**CITY OF NEW YORK  
DEPARTMENT OF DESIGN AND CONSTRUCTION  
DIVISION OF INFRASTRUCTURE  
VOLUME 1 – BID BOOKLET**

**CAPITAL PROJECT SEK002383**  
LOCATION - DEAN ST FROM 6TH AVE TO VANDERBILT AVE &  
VANDERBILT AVE FROM DEAN ST TO PACIFIC ST  
BOROUGH OF BROOKLYN

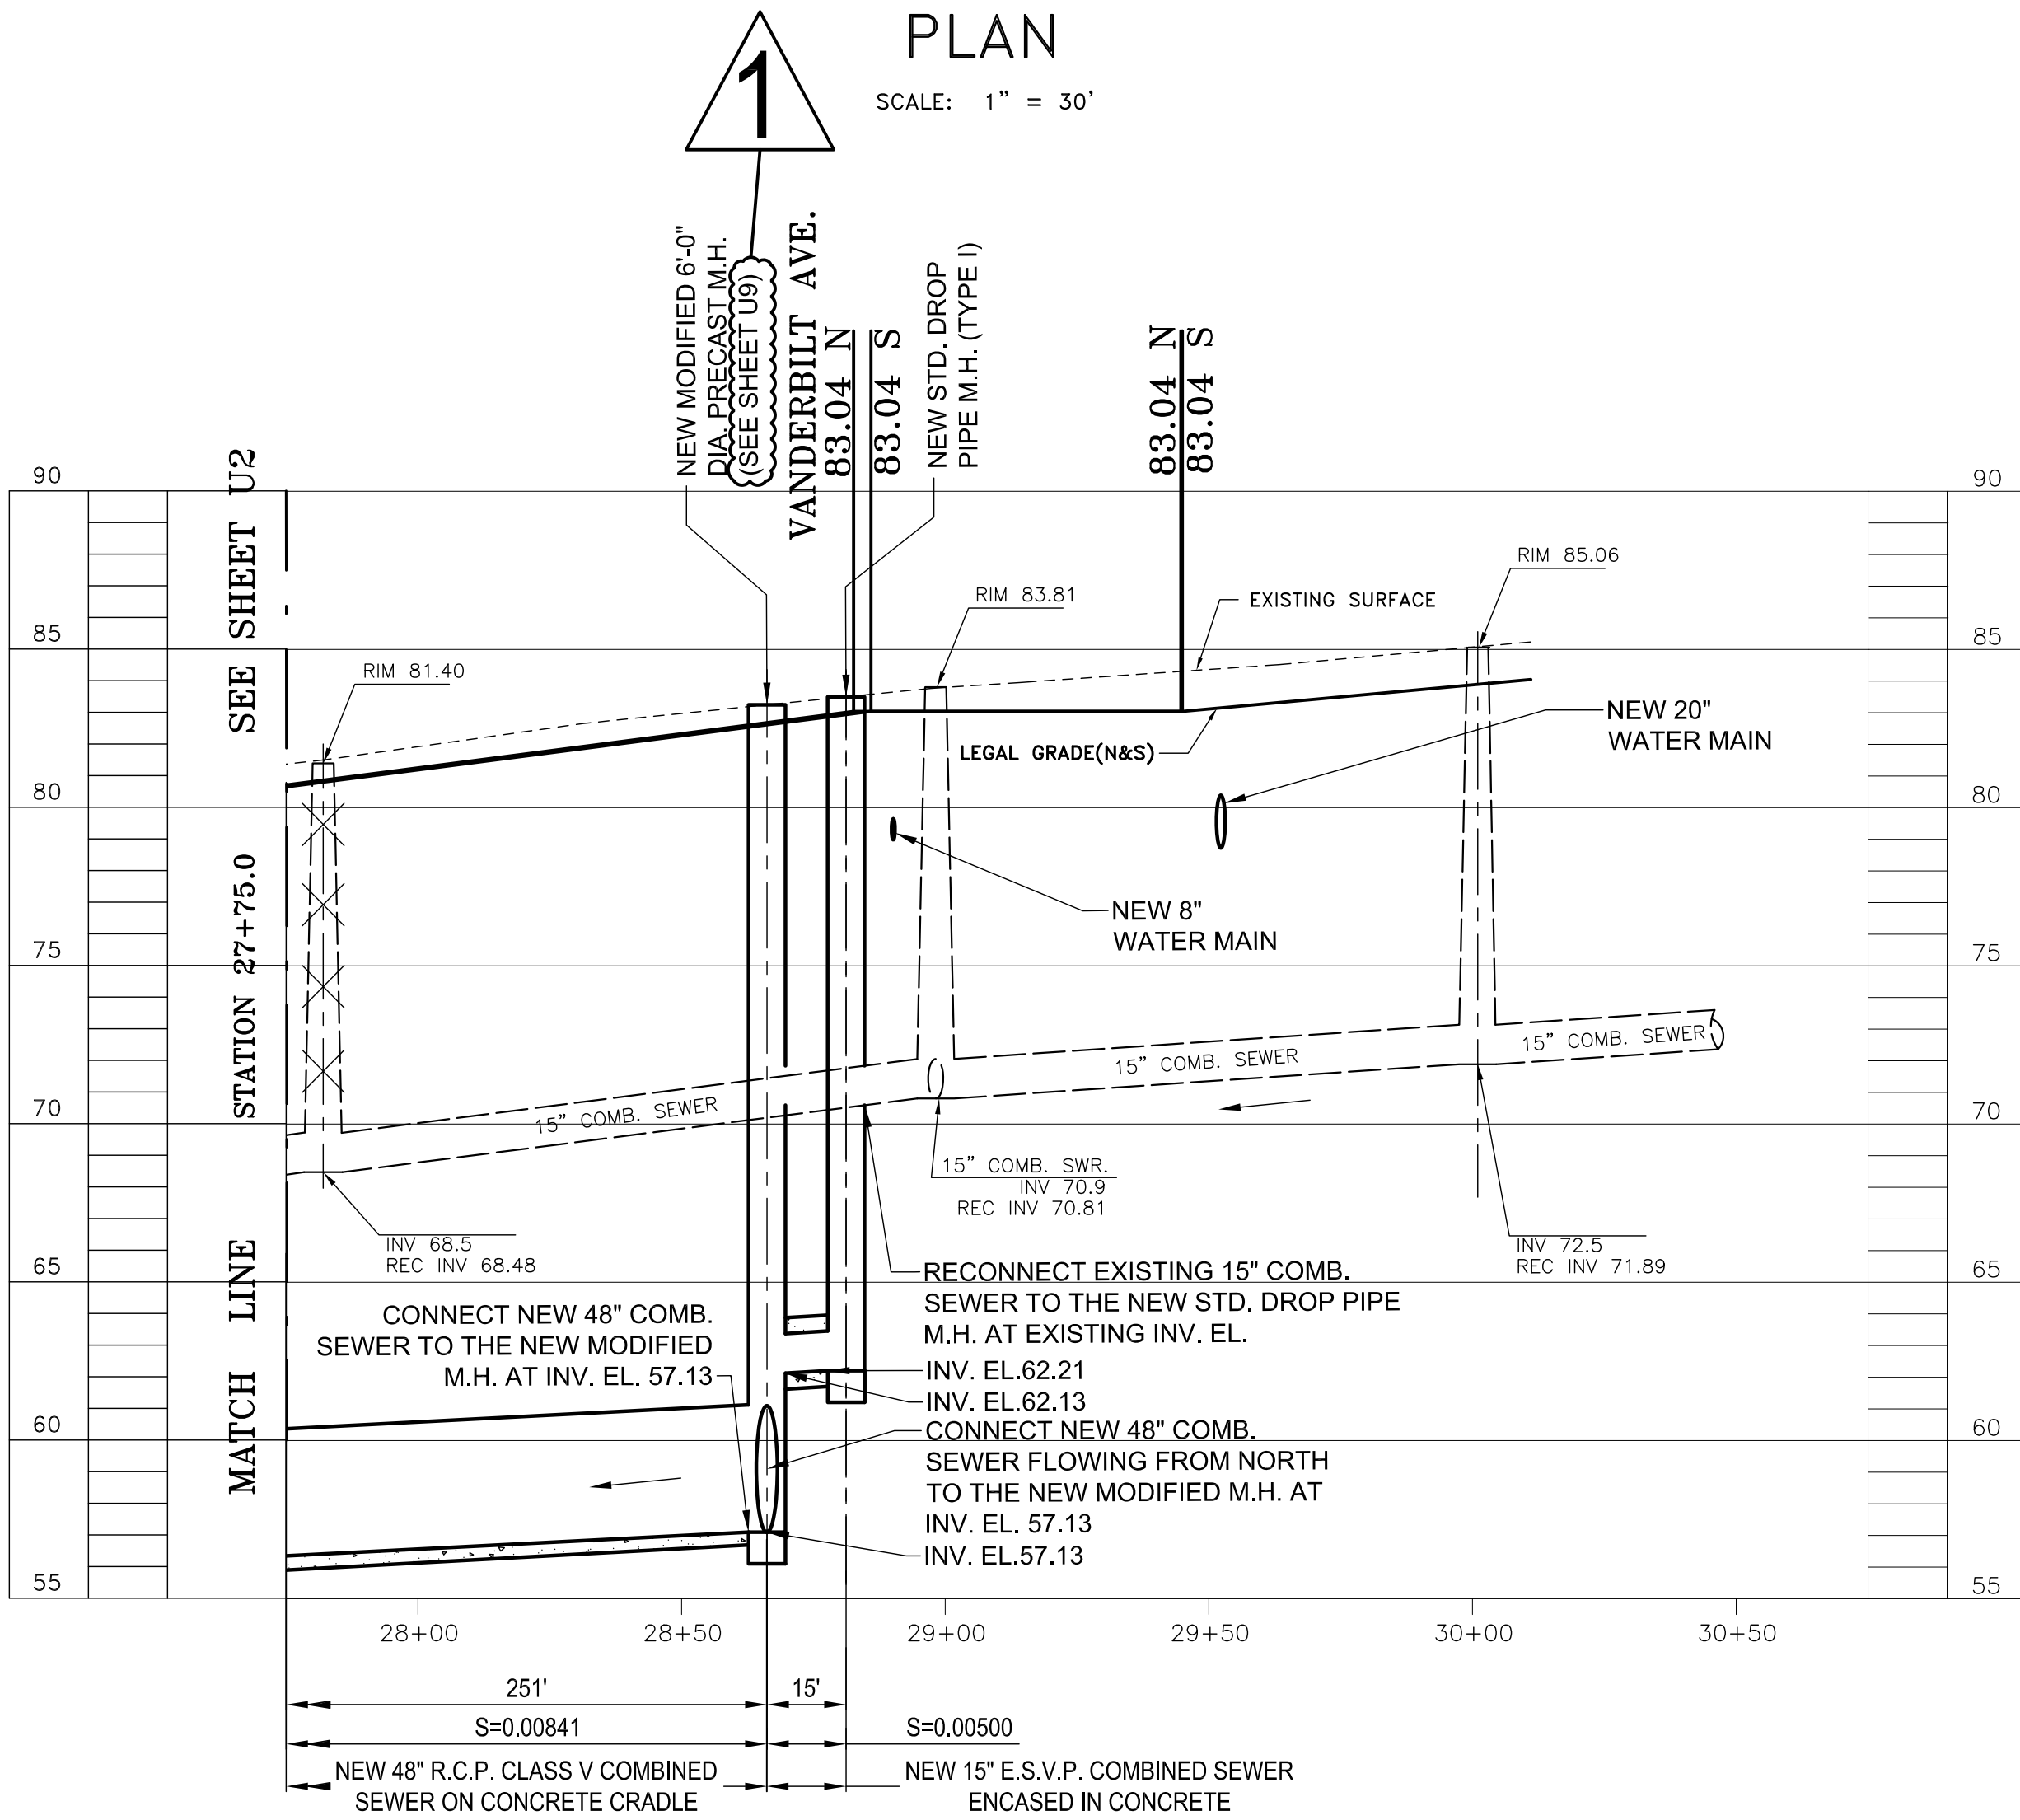
No.	Bidders Question	DDC Responses
6	On Sheet 9 of 39 (U3/U9), the plans show the installation of a new 48" combined sewer class IV on Vanderbilt Avenue, between Dean Street and Pacific Street. However, on Sheet 10 of 39 (U4/U9), the plans show the same sewer as a 48" combined sewer class V. Please clarify whether the 48" sewer on Vanderbilt Ave is a class IV or class V.	1. Please refer to the sewer profile on Sheet 10 of 39 (U4/U9), the new 48" combined sewer on Vanderbilt Avenue, between Dean Street and Pacific Street are class V. Also see ATTACHMENT B for the corrections made.
7	Please confirm that the gas company will cut and loop gas services when requested by the contractor.	National Grid will perform cut and loop services of gas services and for this operation they will require a minimum three business day notification. Contractor will pay the actual cost to the Nation Grid the services.

No.	Bidders Question	DDC Responses
1	Please identify the location of the 20" H.P.G.M. per notes on sheet 9.	In order to identify the location, please refer to <u>NATIONAL GRID GAS NOTES/PROVISIONS</u> note number 2 on sheet 9 of 39 which state that: "CONTRACTOR MUST PERFORM TEST PITS TO VERIFY LOCATION OF THE 20" - 350 PSI TRANSMISSION GAS LINE PRIOR TO PROPOSED SEWER AND WATER MAIN TRENCH CUTS."
2	Are blowups of the intersections available? Due to the many utility lines shown and the lack of clarity, it's difficult to see.	Blowups of the intersections are not available.
3	What is the expected start date?	Start date can not be envisaged at this period of time.
4	Will utility company work be allowed to delay the start of the project?	No.
5	Note 5.07 on sheet 3 indicates payment for cleaning existing catch basins is paid under Item 6.50. Will that Item be added to the bid schedule?	Item #6.50 is not required for this project.

No.	Bidders Question	DDC Responses
9	<p>On sheet 9, under the NATIONAL GRID NOTES, note 2 stipulates only wood sheeting be utilized to support and protect National Grids 20" H.P. gas line. The term "wood sheeting" traditionally refers to vertical wood planks supported by timber walers and braces.</p> <p>A) Is that the intent is here?</p> <p>B) If so, exactly what distance from the centerline of the gas main to the end of the wood sheeting is required?</p> <p>C) Our preliminary analysis indicates that given the following criteria, wood sheeting is not reasonably feasible: a limited amount of space in a busy intersection (11' min at a time); limited work hours (9-3); nightly decking required; and most relevant, a 27' cut. Has DDC performed a constructability analysis for wood sheeting in this situation?</p> <p>D) Prior to bidding, the contractor has no knowledge as to whether National Grid and DDC will accept any alternate methods of sheeting. Acceptable sheeting alternates should be disclosed prior to bidding. To avoid guessing, what alternates would be acceptable to National Grid and DDC?</p>	<p>Please refer to NYCDEP standard specifications SECTION 40.05 in general for SHEETING AND BRACING and its sub section 40.05.1 in particular for guidance regarding use of other sheeting systems which will be subject to the approval by NYCDDC.</p>
